ORIGINATION FORM

Proposed Revisions to a Standard Plans Index
(Please provide all information – Incomplete forms will be returned)

Index Number: **580-001**
Sheet Number (s): 1 and 2 of 2
Index Title: Landscape Installation

Sheet 1: Changed General Notes; Changed the Under 4" and 4" and Larger Caliper Tree sizes; Changed the Stake Spacing, Anchors and Mulch callouts.
Sheet 2: Changed the Under 4" and 4" and Larger Caliper Tree sizes; Changed the Stake Spacing, Anchors and Mulch callouts; Changed the Palm Planting Note; Changed the Min. Wood Braces callout for the Palm Planting on Slope.

LAST REVISION 11/01/17	DESCRIPTION:		FY 2018-19 STANDARD PLANS	LANDSCAPE INSTALLATION	INDEX 580-001	SHEET 1 of 2
---------------------------	--------------	--	------------------------------	------------------------	------------------	-----------------

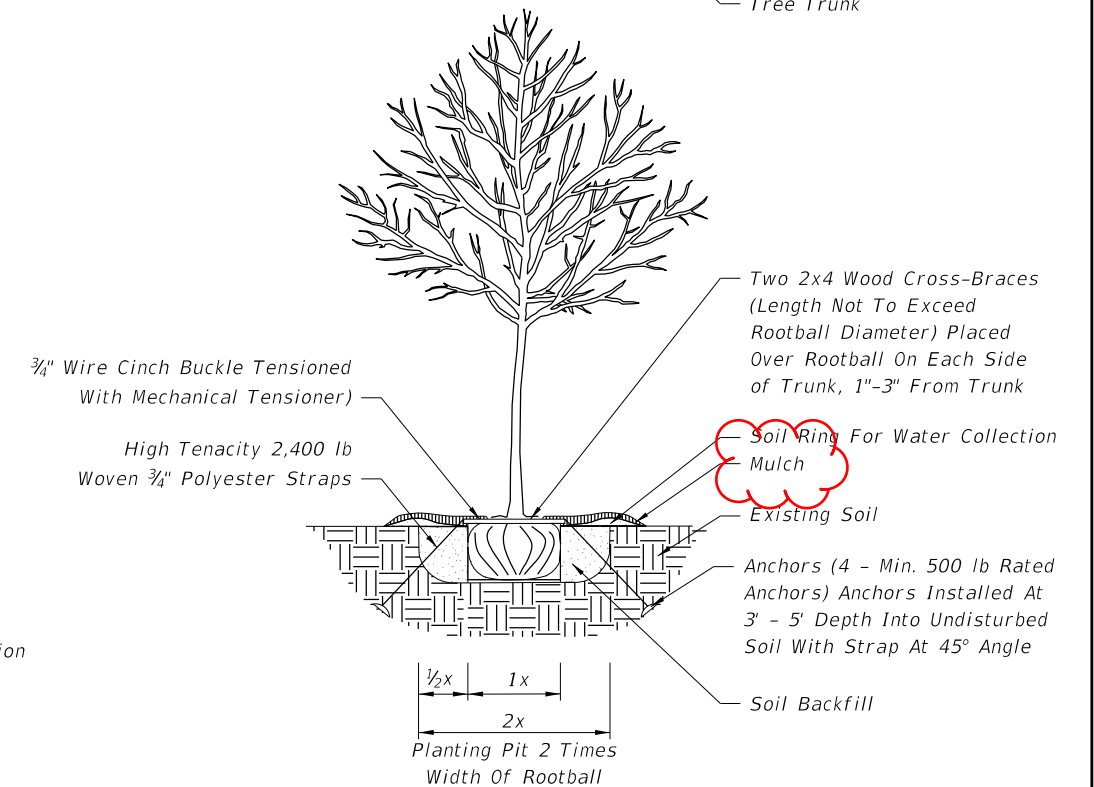
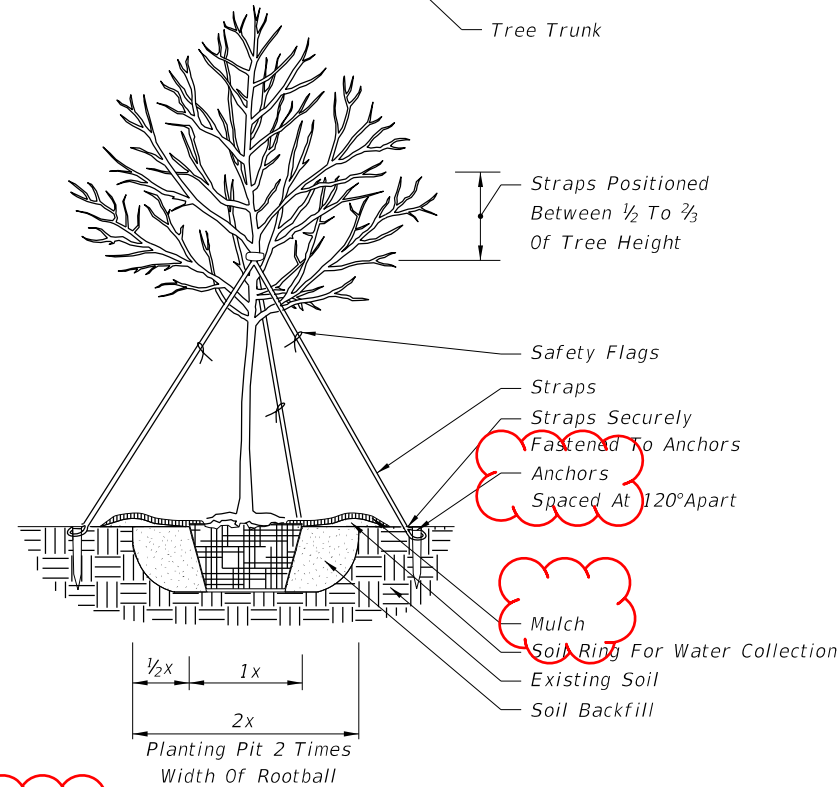
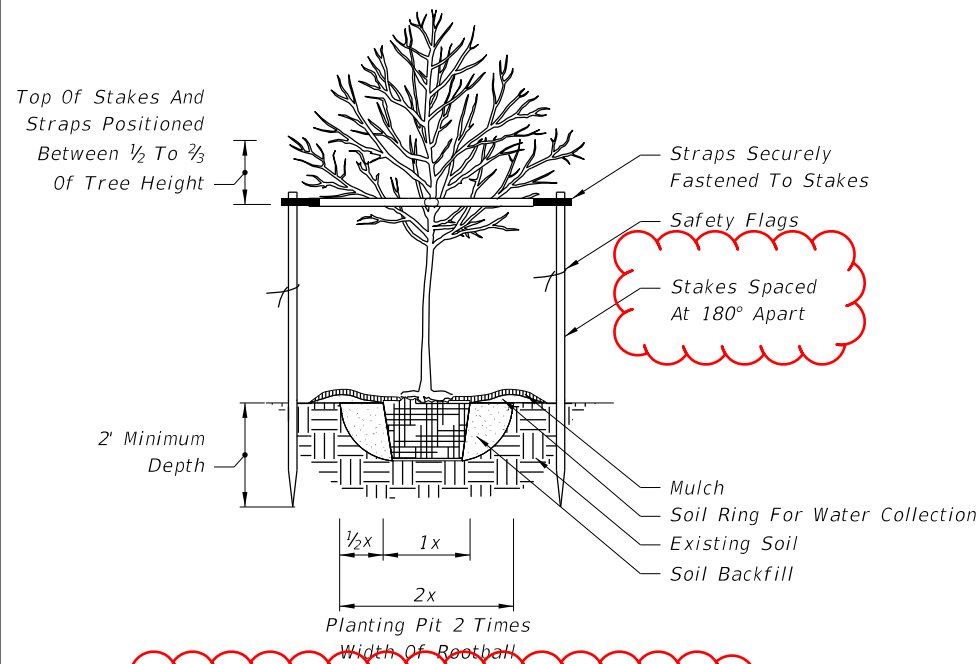
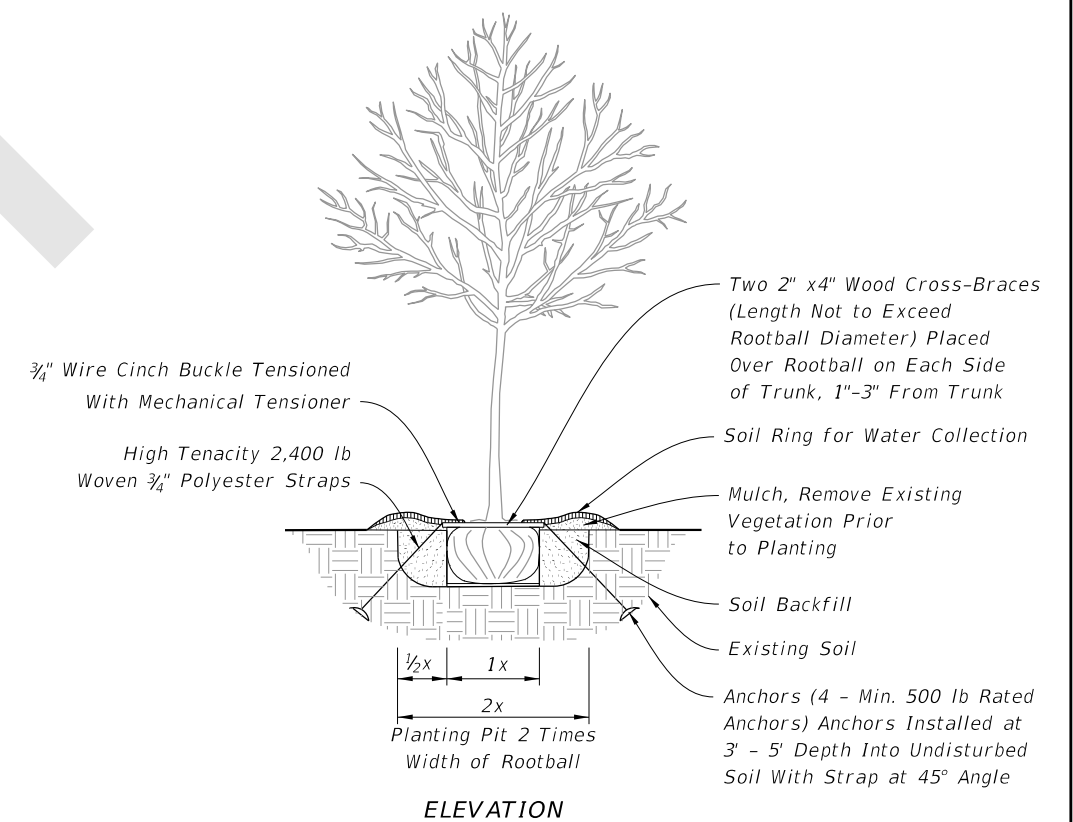
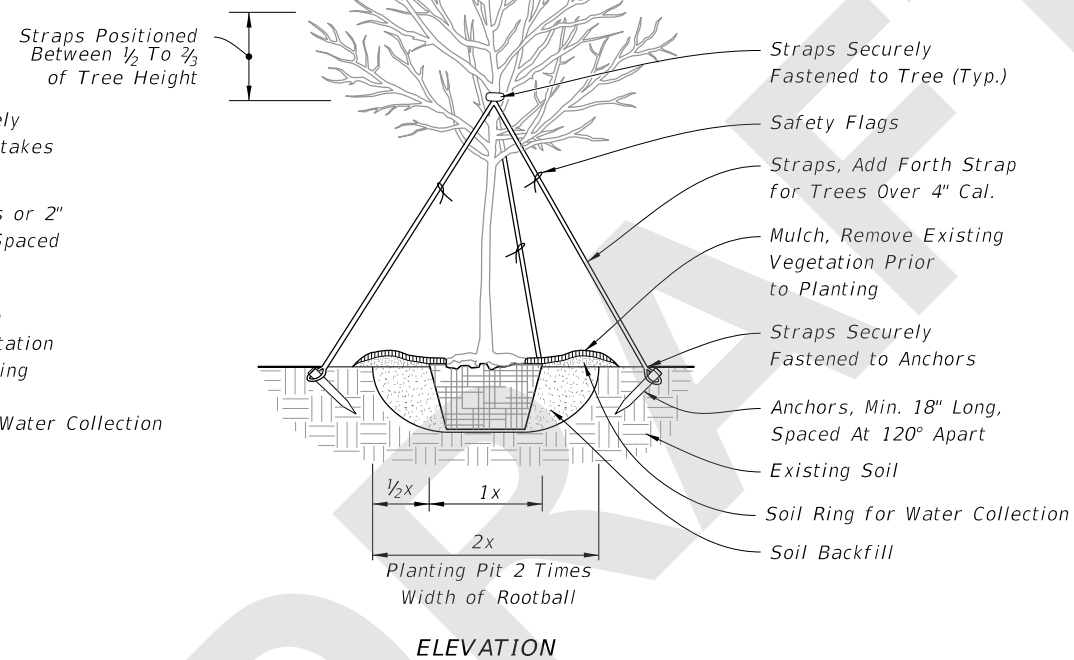
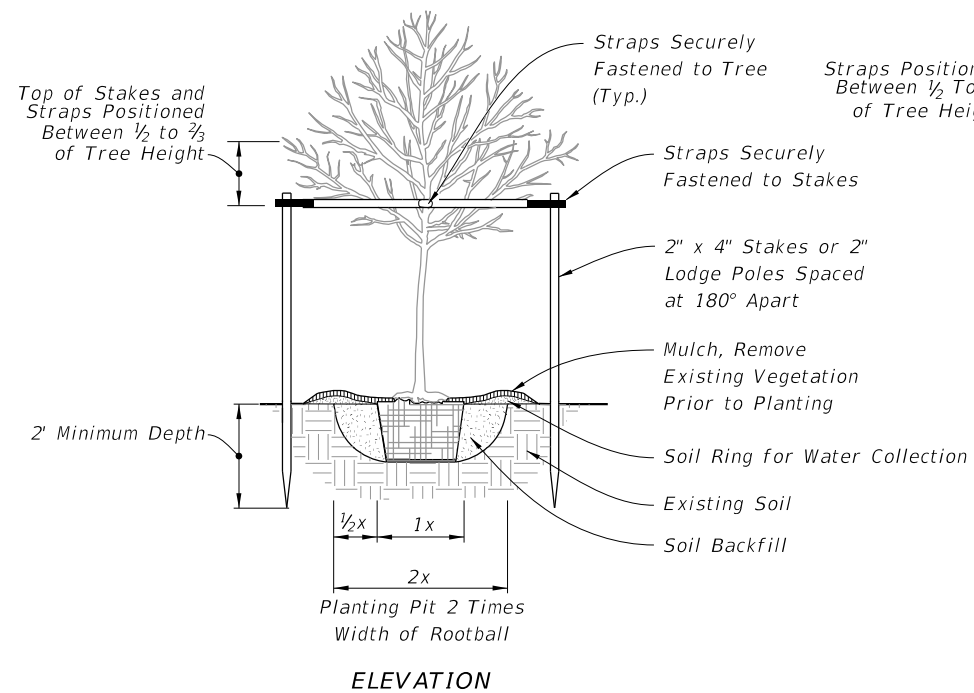
Changed Notes

UNDER 2 1/2" CALIPER TREE PLANTING

2 1/2" TO 6" CALIPER TREE PLANTING
